Subject: P.H.O. APPLICATION NO. PHO-1-26--Z-29-23-7(8) – Notice of Pending Actions by the Planning Hearing Officer

APPLICATION NO: PHO-1-26--Z-29-23-7(8)

Request For: Stipulation Modification

Property Location: Approximately 300 feet east of the northeast corner of 43rd Avenue and Baseline Road

preliminary site plan

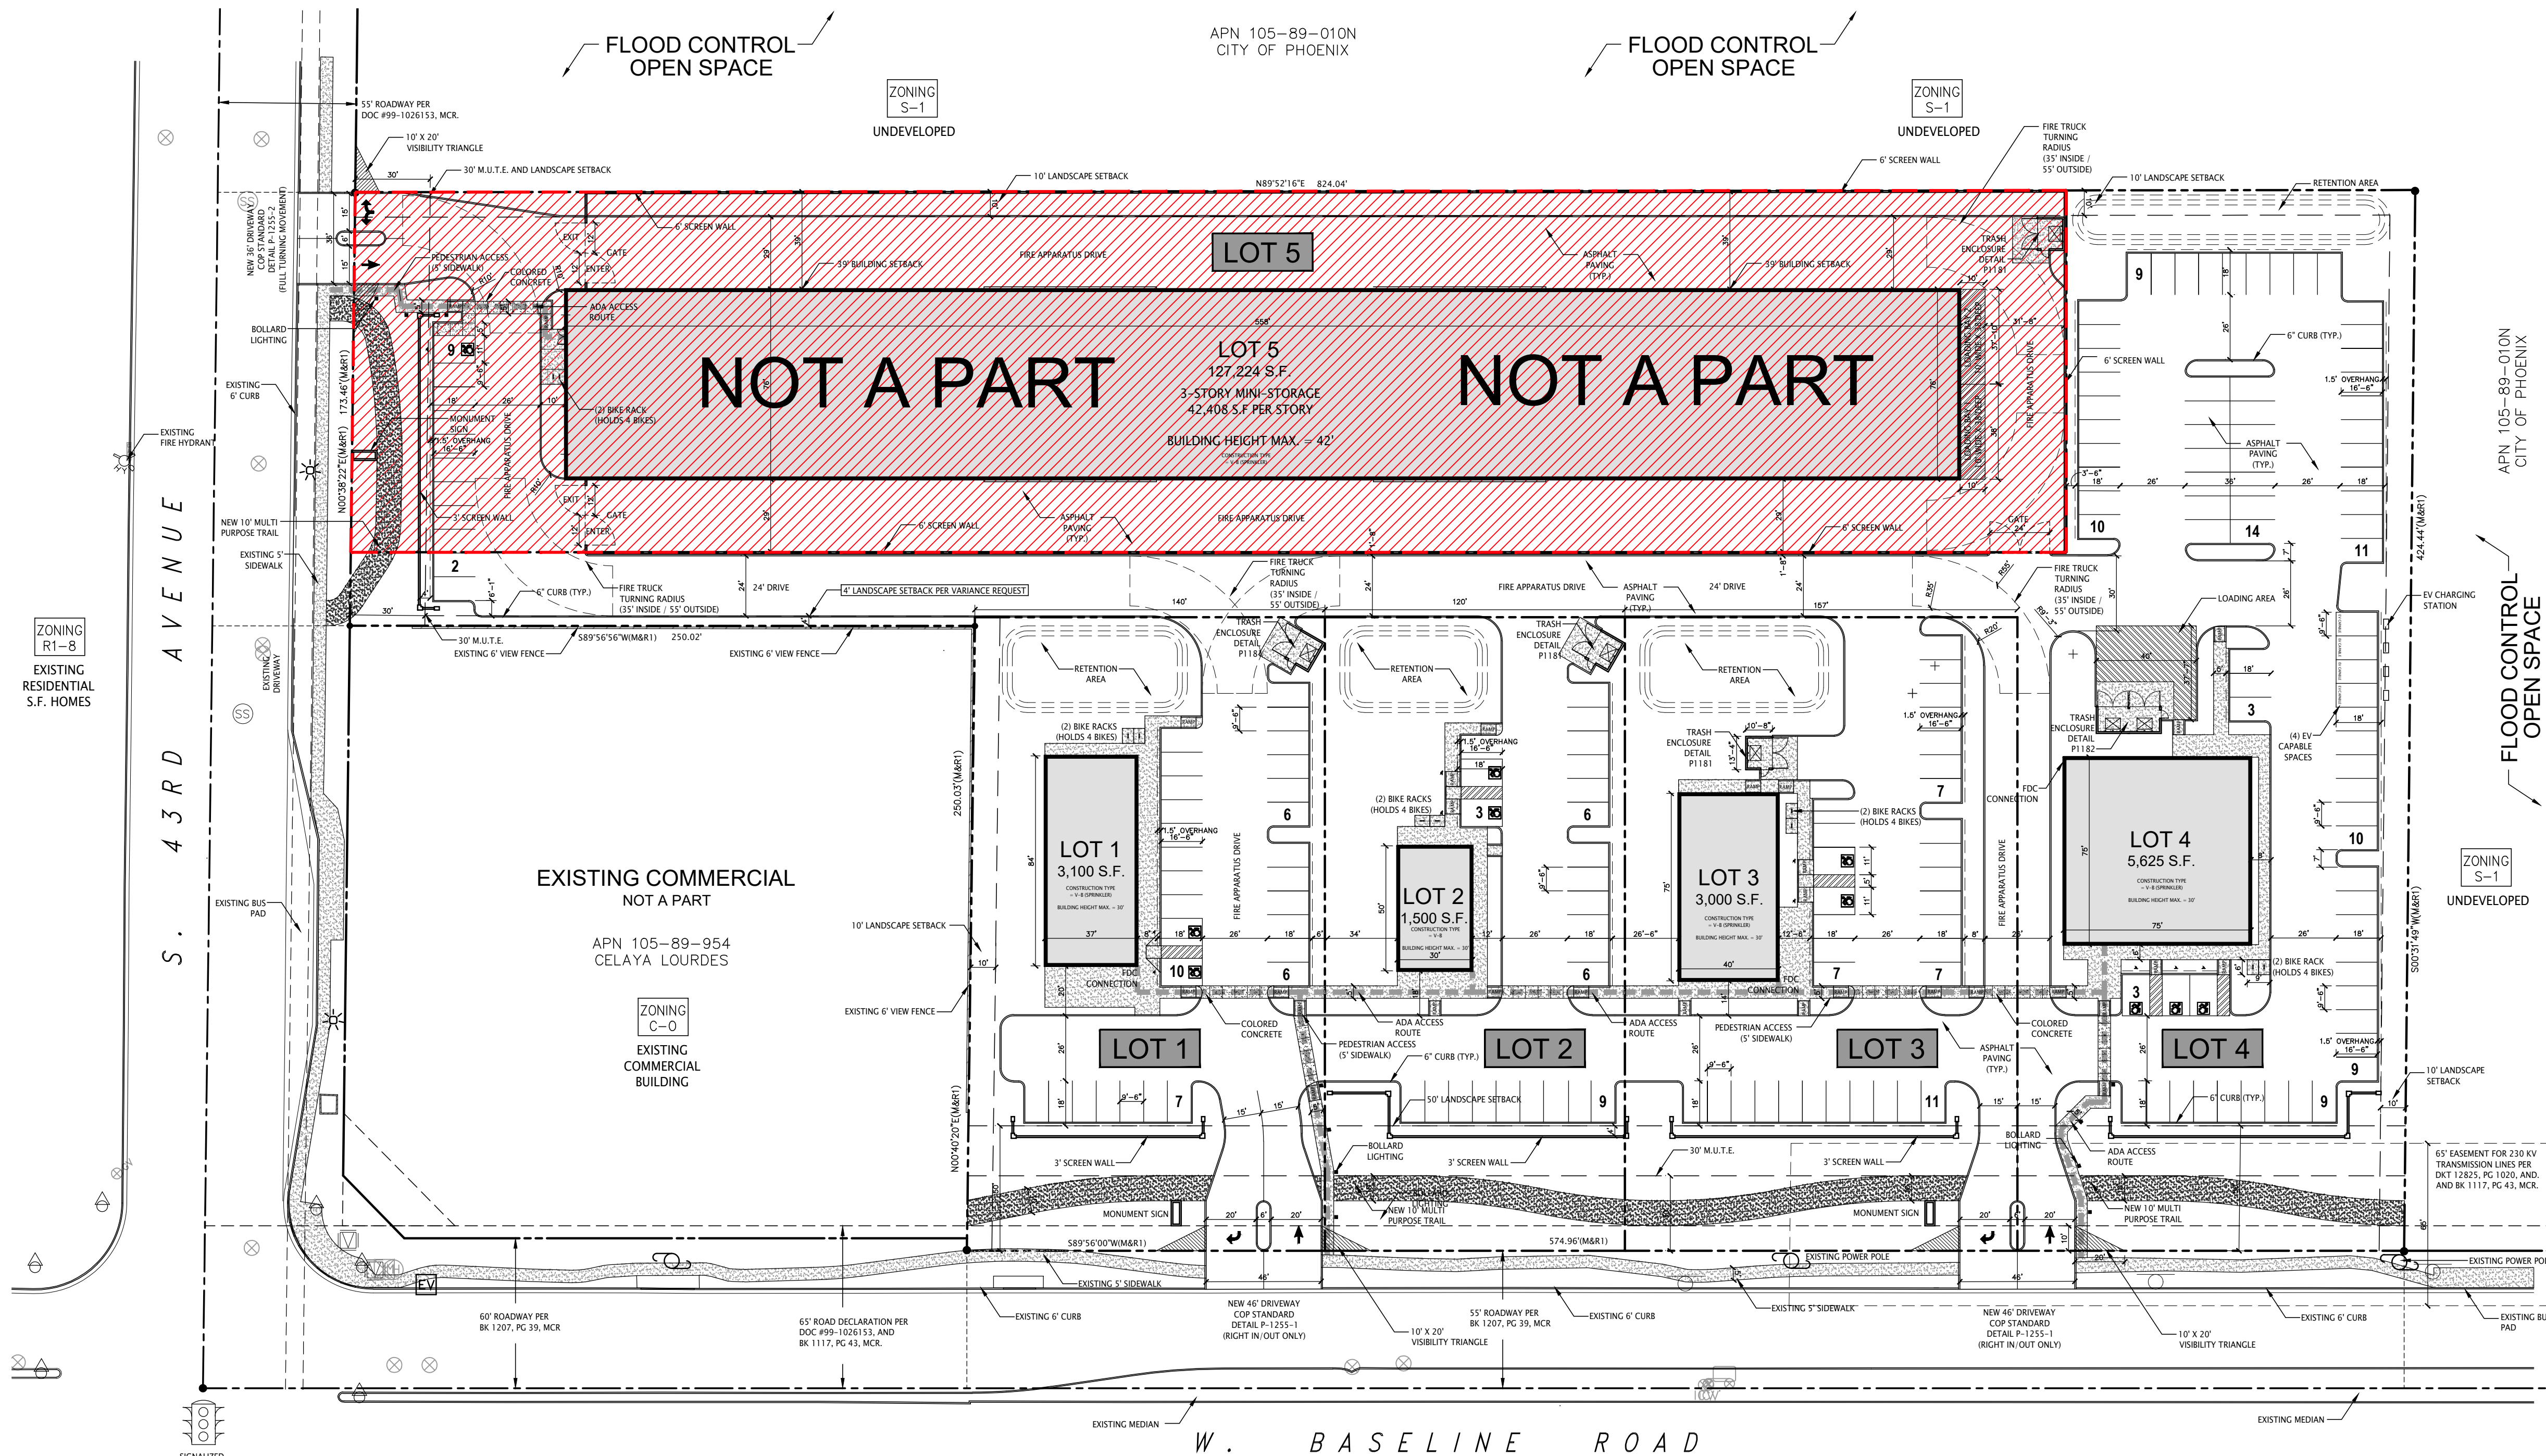
Lots 1, 2, 3, and 4, ~~and 6,~~ as depicted on the Site Plan date stamped ~~August 18, 2023~~ March 26, 2026

Stipulation 19: Conceptual site plan and elevations for Lot 4 ~~and Lot 6~~ shall be reviewed and approved by the Planning Hearing Officer (PHO) through the public hearing process for stipulation modification prior to preliminary site plan approval. This PHO review is a legislative review for conceptual building elevations only. Specific development standards and requirements may be determined by the PHO and the Planning and Development Department.

Response: As discussed above, the 2025 Rezoning Case eliminated Lots 5 and 6 on the site plan of the 2023 Rezoning Case. As such, the request is to modify the above stipulation to remove the reference to Lot 6 and update the date of the site plan.
